Product / Process Change Notification (PCN)

PCN #:	PCN_WL-SMDC_20181201	Change Category:	<input type="checkbox"/> Equipment / Location
Affected Series:	WL-SMDC 150353FS74500 / 150353HS74500		<input type="checkbox"/> General Data
PCN Date:	August 31, 2018		<input type="checkbox"/> Material
Effective Date:	December 01, 2019		<input type="checkbox"/> Process
			<input checked="" type="checkbox"/> Product Design
			<input type="checkbox"/> Shipping / Packaging
			<input type="checkbox"/> Supplier

Following are pictures of the old and the new products

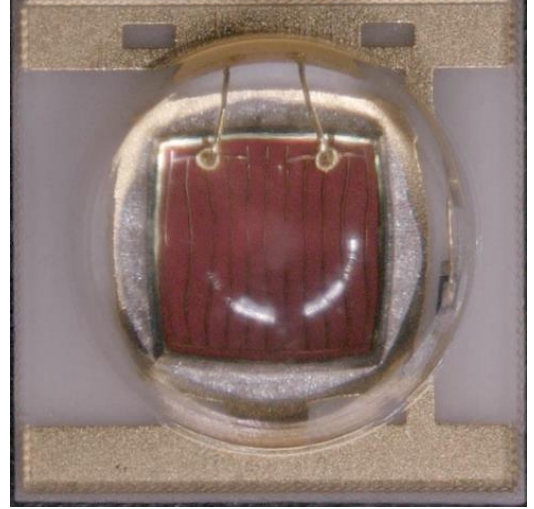
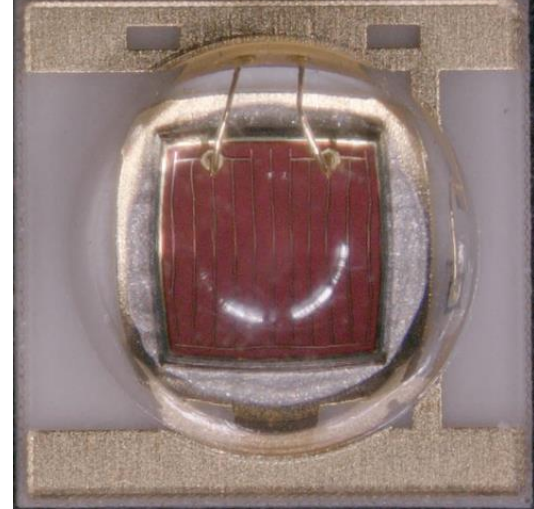
The chip of the products will be upgraded to the latest generation and the power output of the products will change accordingly:

Optical parameter	150353HS74500		150353FS74500	
	Before	After	Before	After
Φ_v minimum [mW]	240	360	180	280
Φ_v typical [mW]	330	400	240	330
